Item # 2

Request DTC Revision and Modification Project Name 5th & Peabody Dual Flag Hotel

Council District 19 – O'Connell

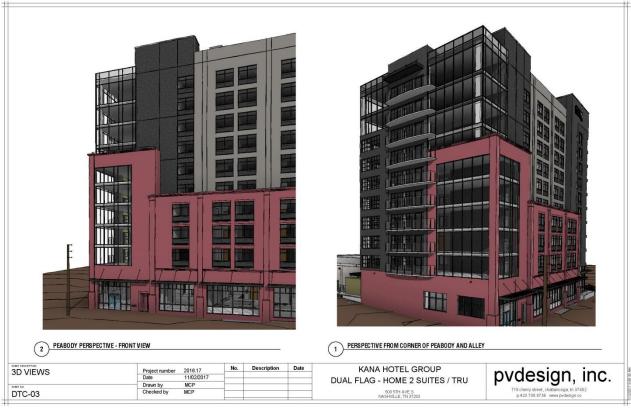
Along Peabody Street, the DTC requires a 0'-10' build-to zone with a 15 foot step-back between the 4th and 7th stories, for buildings greater than 7 stories. The hotel/retail portion of the building previously received modification approval to allow a 6 foot step-back along Peabody Street. This was due to the building being setback to provide a wider sidewalk than the 8 feet that is required and the negligible difference in step-back as measured from the property line. The proposed condo addition to the building is setback 7 (+/-) feet from the property line and proposing a 5'6" step-back. Since the building is setback from the property line, the difference in the location of the step-back from the property line is only approximately 2 feet. This is consistent with the previously approved step-back for the hotel.

The addition of residential into the building is in line with the guiding principles of the Downtown Plan to encourage a mixture of uses that help to create a 24/7 community. The condos are differentiated from the hotel with materials and a step-back that occurs on the 7th floor, whereas the step-back of the hotel portion occurs on the 5th floor. The brick and glass condo addition also helps to mask the blank wall of the stair tower and add interest and activity to that corner of the building.

In regards to the modification for the upper floor to floor heights, the applicant is proposing 9'4" where 10 feet is required. The floor to floor heights have not changed from the previously approved drawings. This is a minor modification and consistent with previously approved hotel developments.

Planning staff recommends approval of the revisions to the previously approved hotel/retail building and modifications to the step-back standard for the condo addition and upper floor heights for the full building.
